6 City Center Exterior Renovations

Title
DEMOLITION PLANS

Sheet
D1

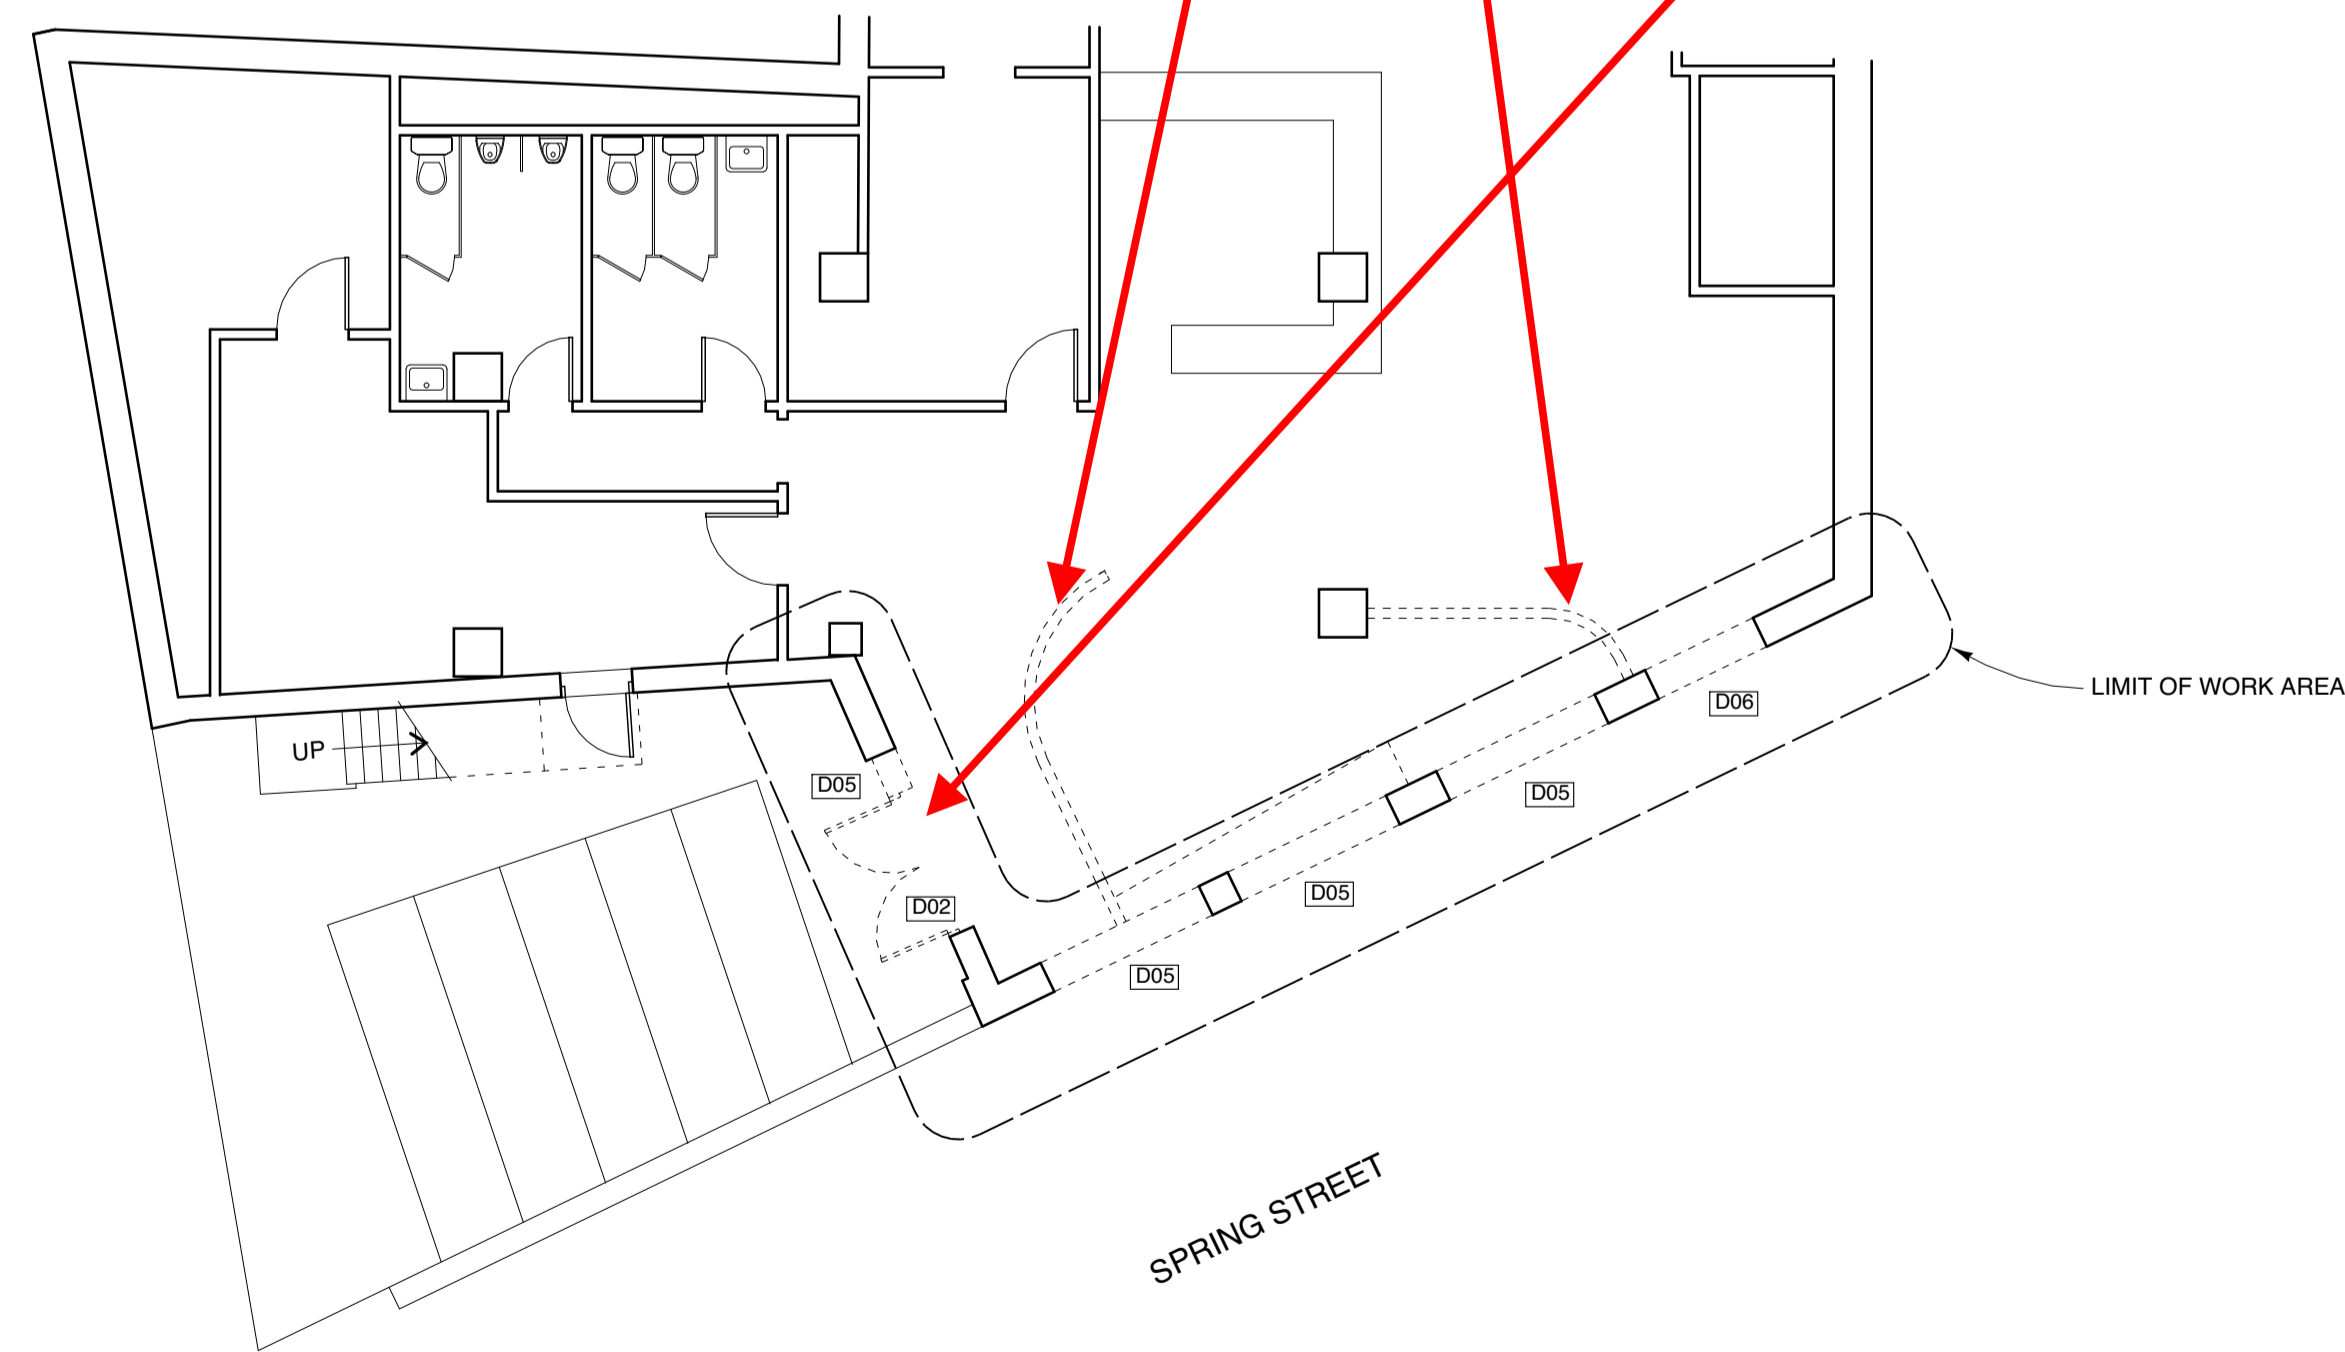
Please note what this demo reflects as this is interior work, not a part of this project scope

Please provide a life safety plan for each floor which addresses the occupant load, proposed reduction of egress width and removal of the fire escape
